## **BID ADDENDUM NO. 3**

### **Johnson Student Center**

### **Building Demolition, Increment 1 (Demolition) and Increment 2**

RANCHO SANTIAGO COMMUNITY COLLEGE DISTRICT  
SANTA ANA, CA

**E1.01**

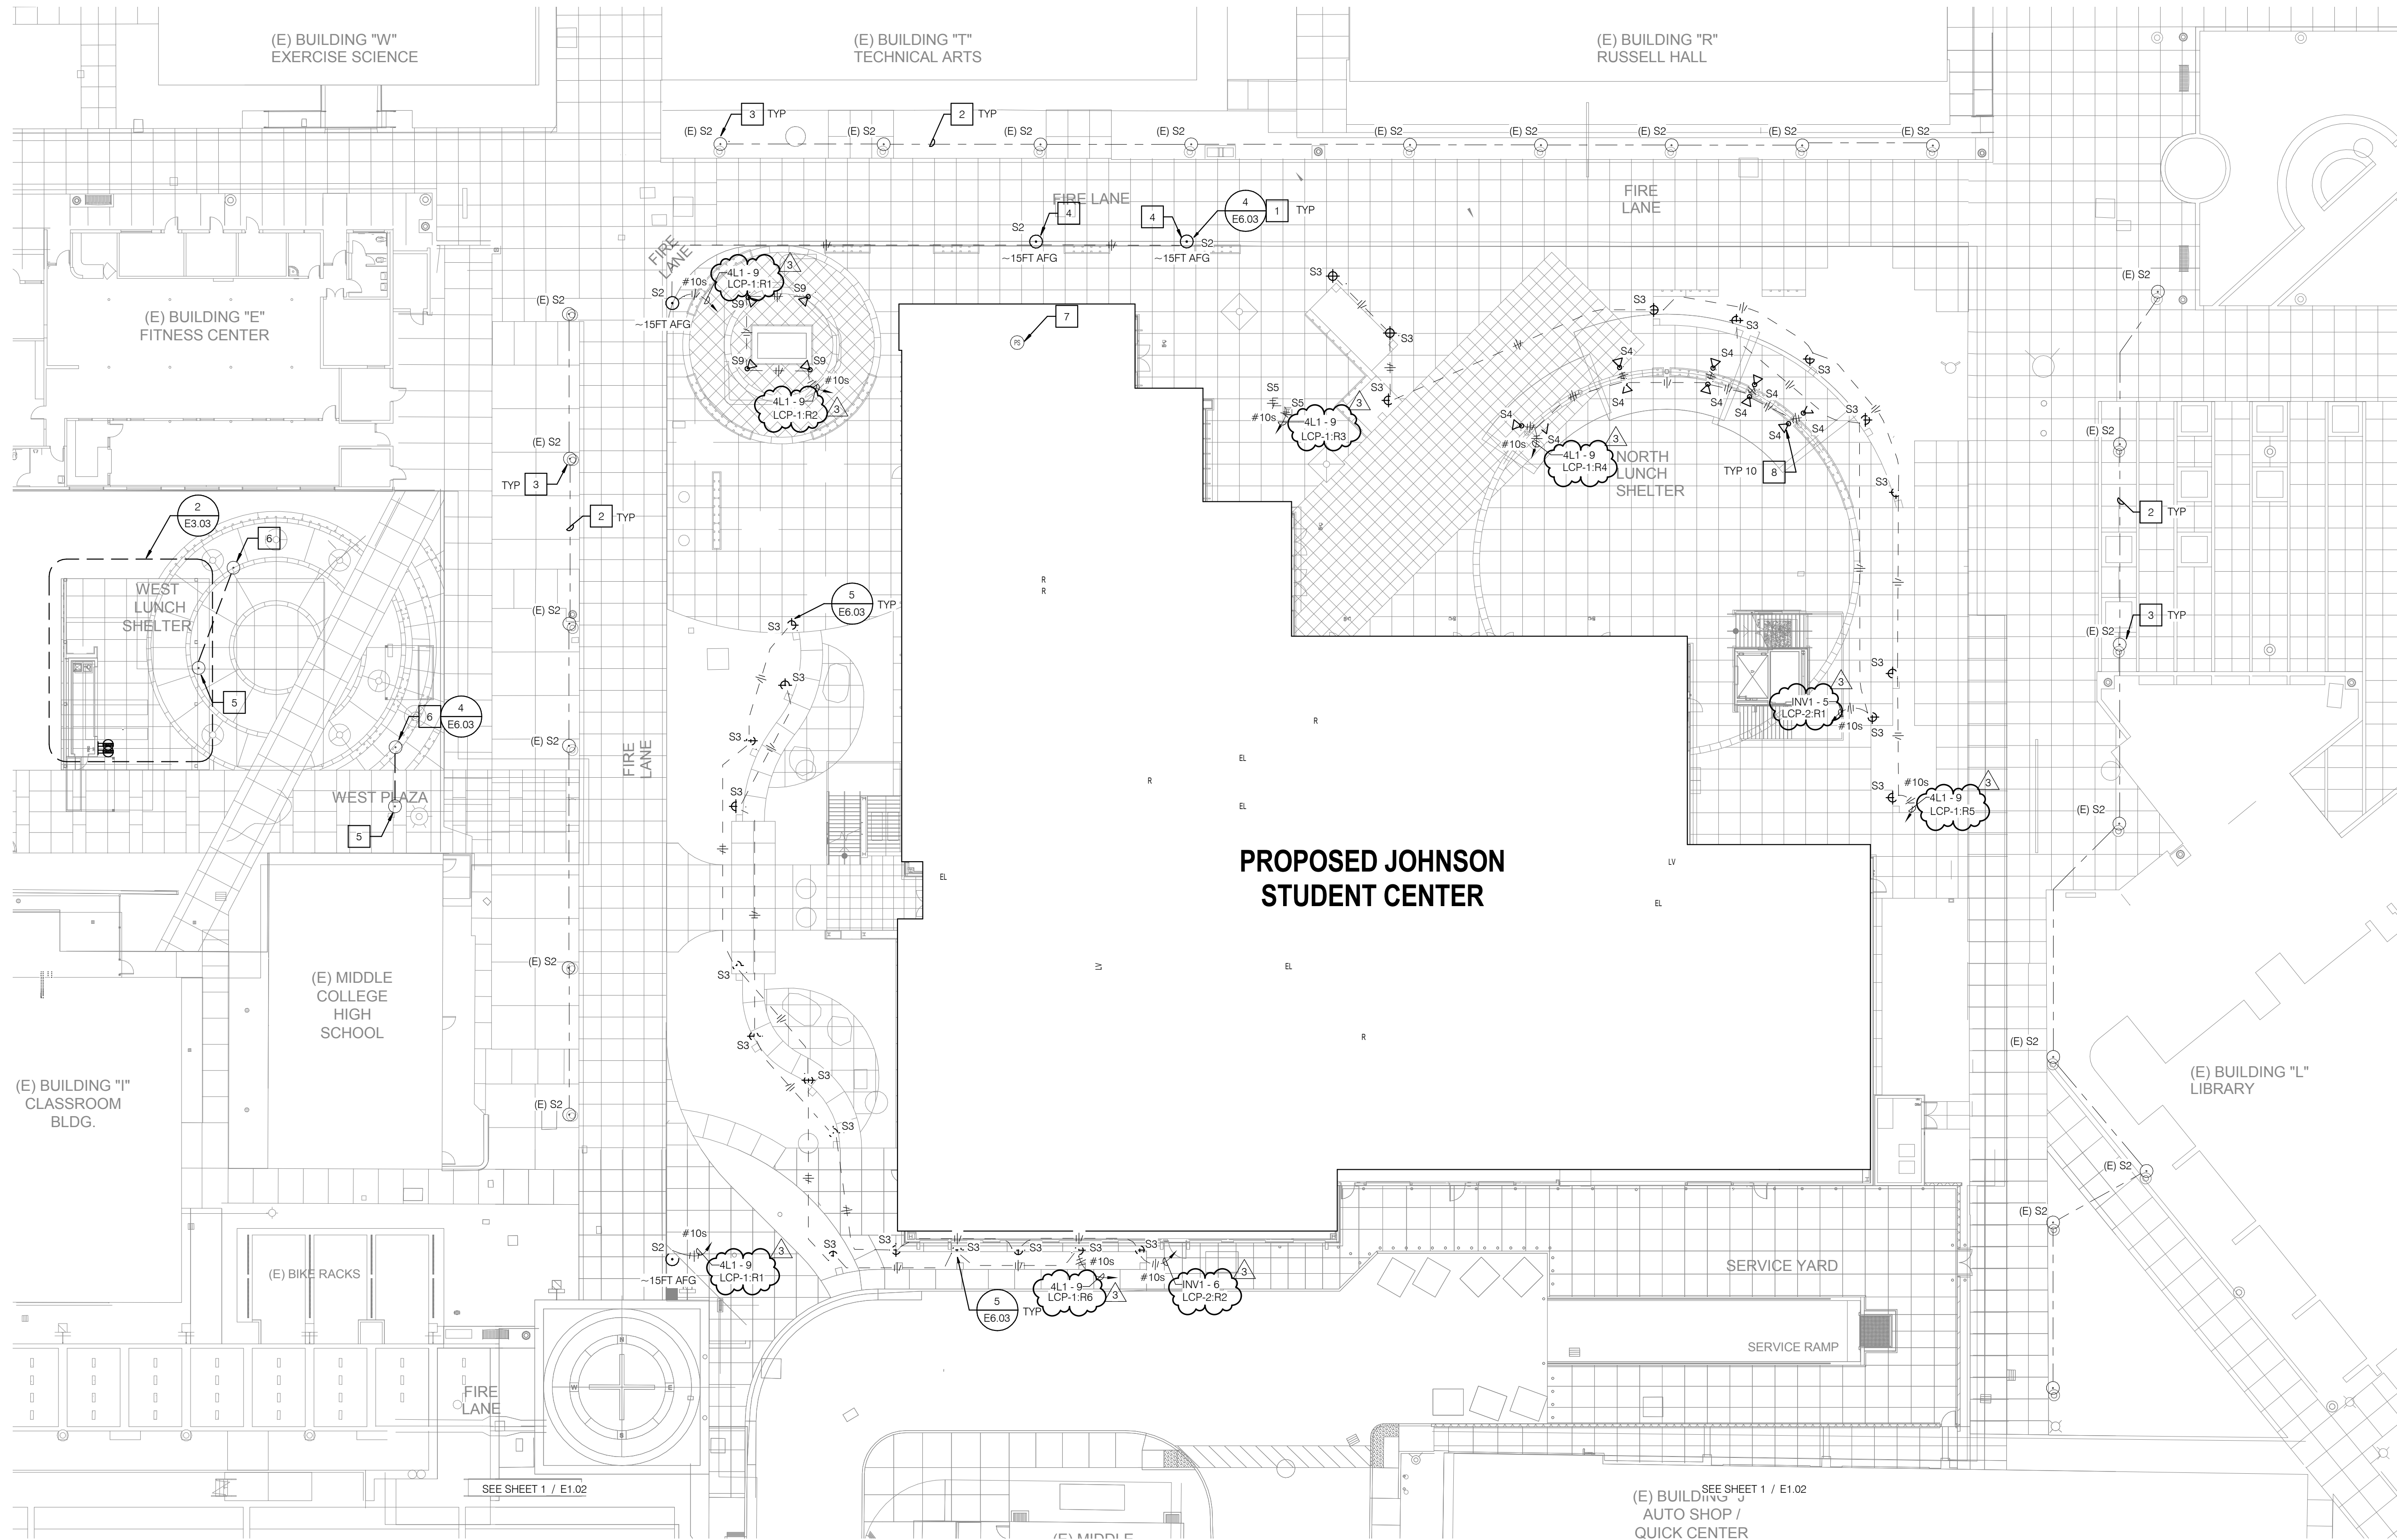
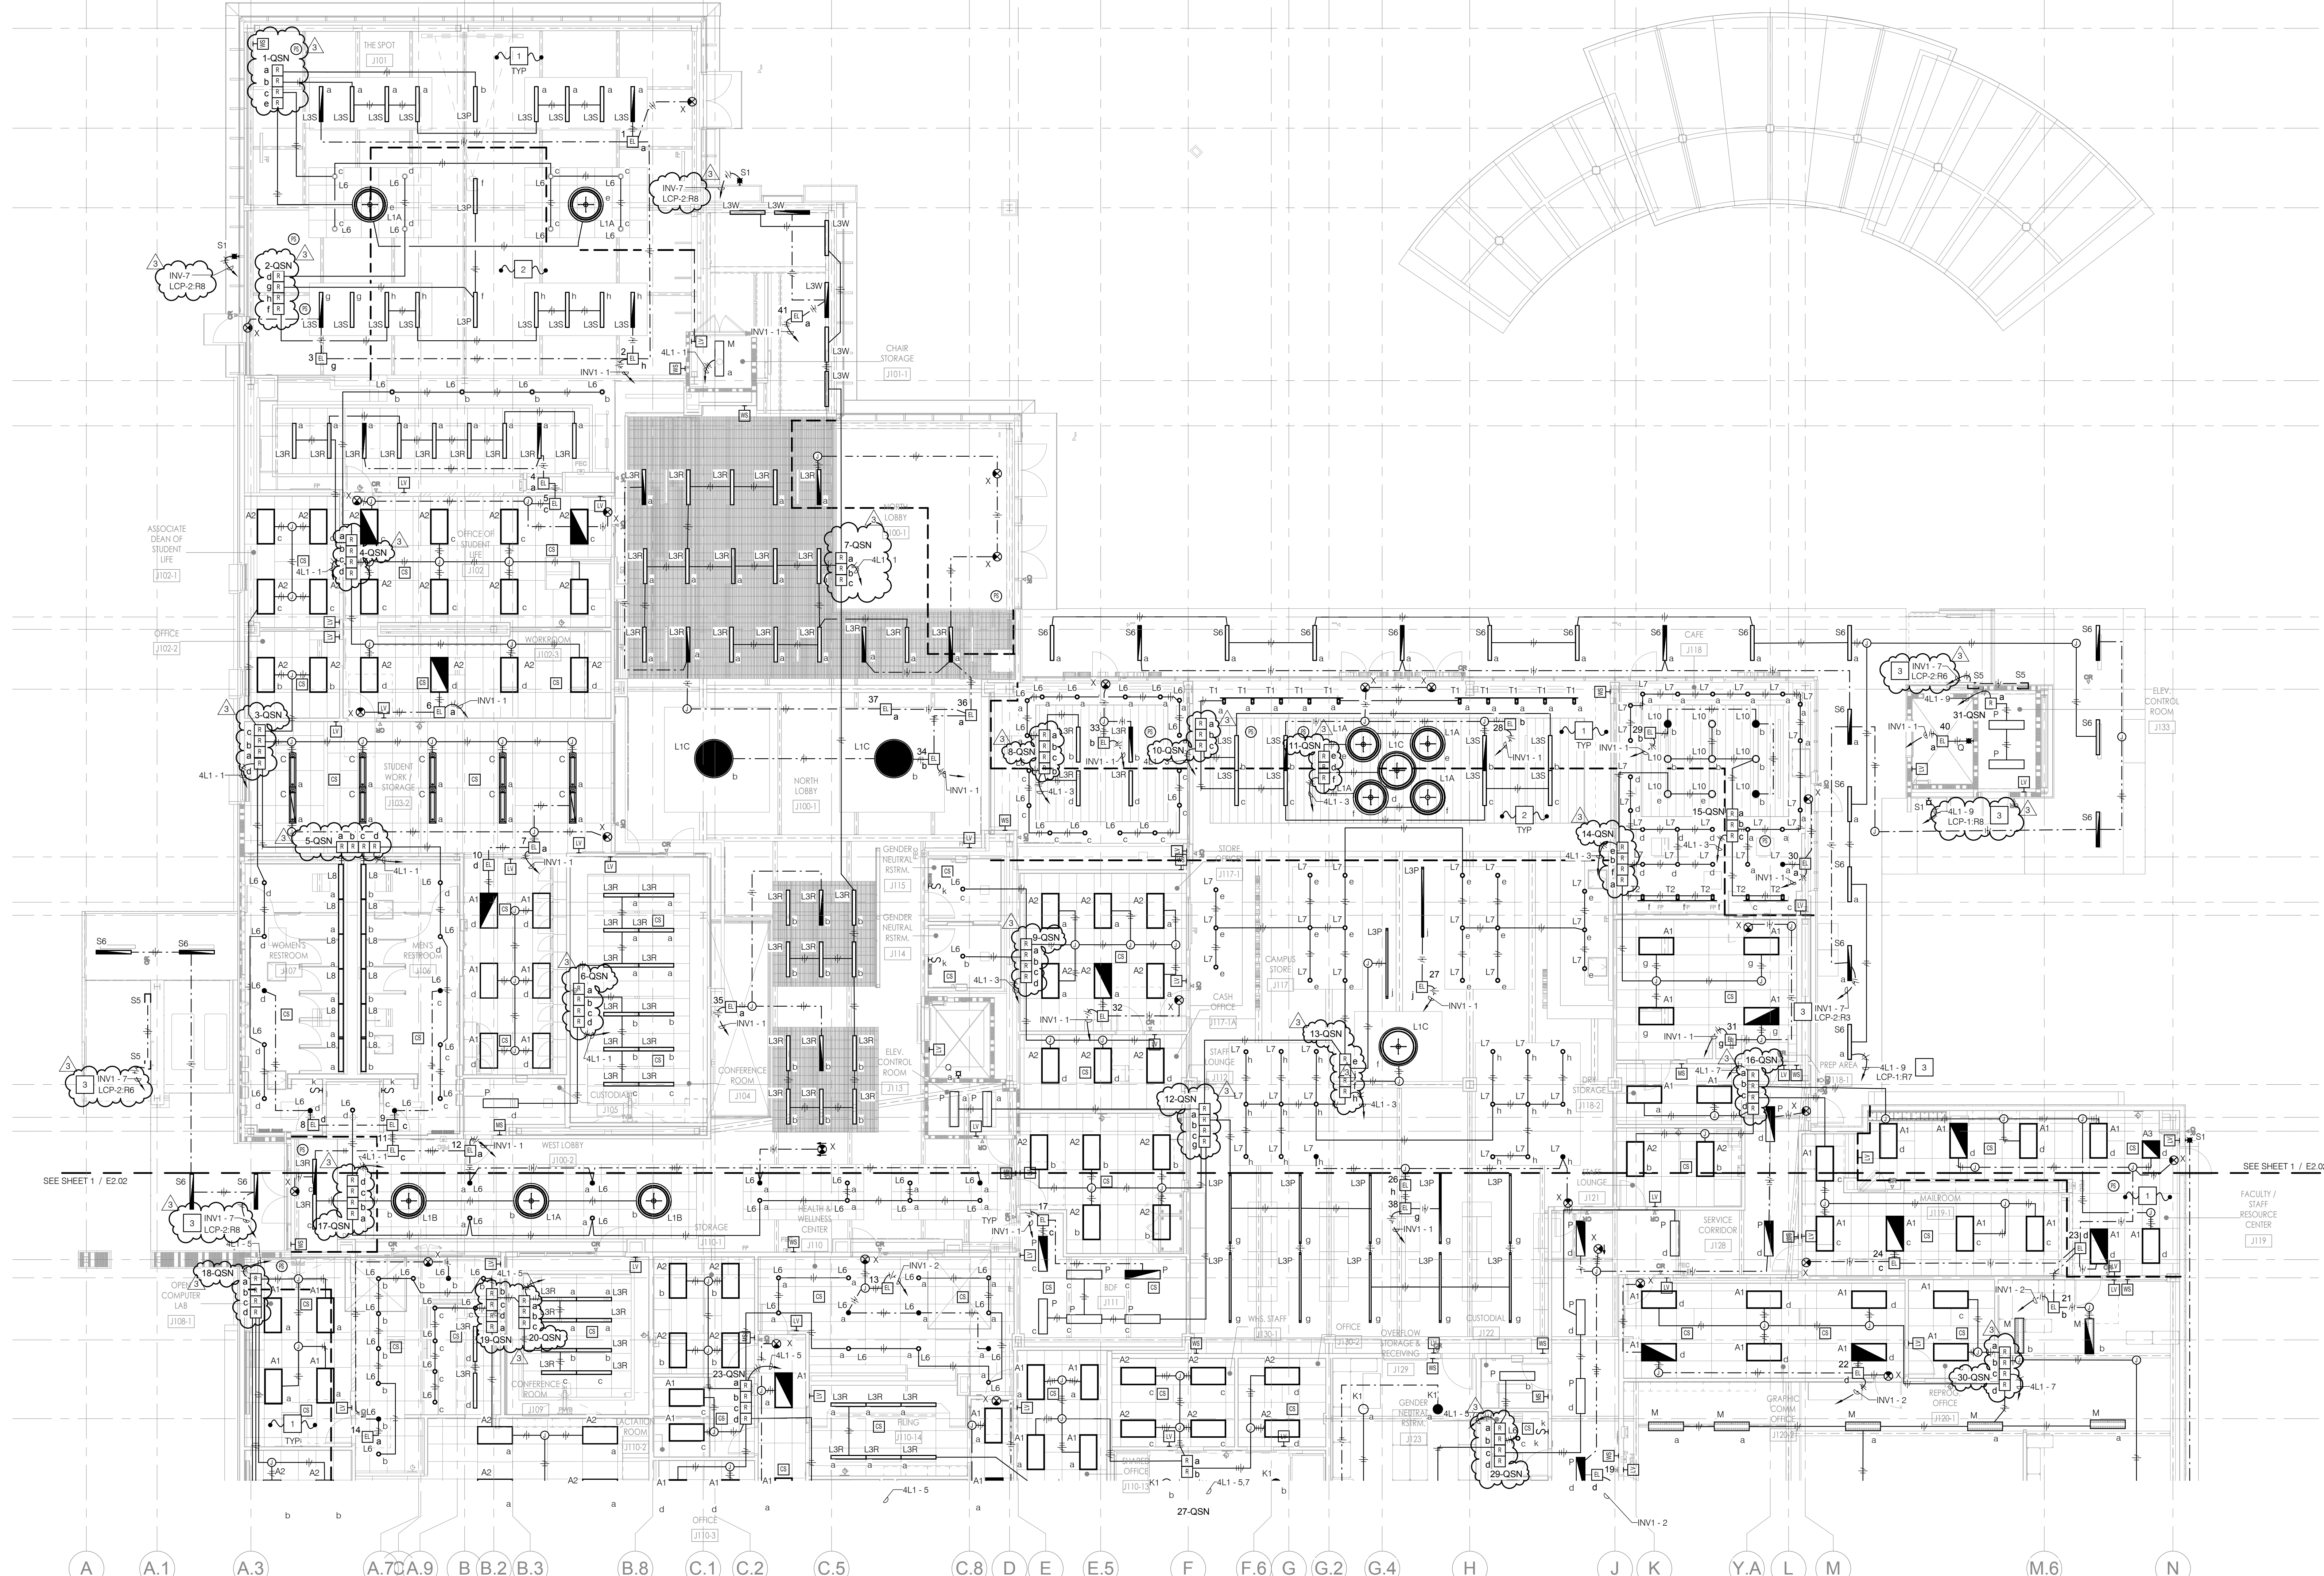
- Increment 2
  - i. Lighting Control System manufacturer change per District:
    1. Revised Electrical Drawings to reflect changes from WattStopper Digital Lighting Management (DLM) to “Lutron Quantum” to match campus standard. Refer to full size sheets attached.

- PROVIDE ENERGY SAVI NODES QSN-2116-S FOR CONTROL OF EMERGENCY LIGHTS. COMBINE (4) EL DEVICES SHOWN ON PLAN TO (1) QSN-2116-S DEVICE. PROVIDE LUT-ELI FOR EMERGENCY LIGHTING INTERPHASE. INSTALL PER MANUFACTURER REQUIREMENTS. REFER TO DETAIL 1.6055.
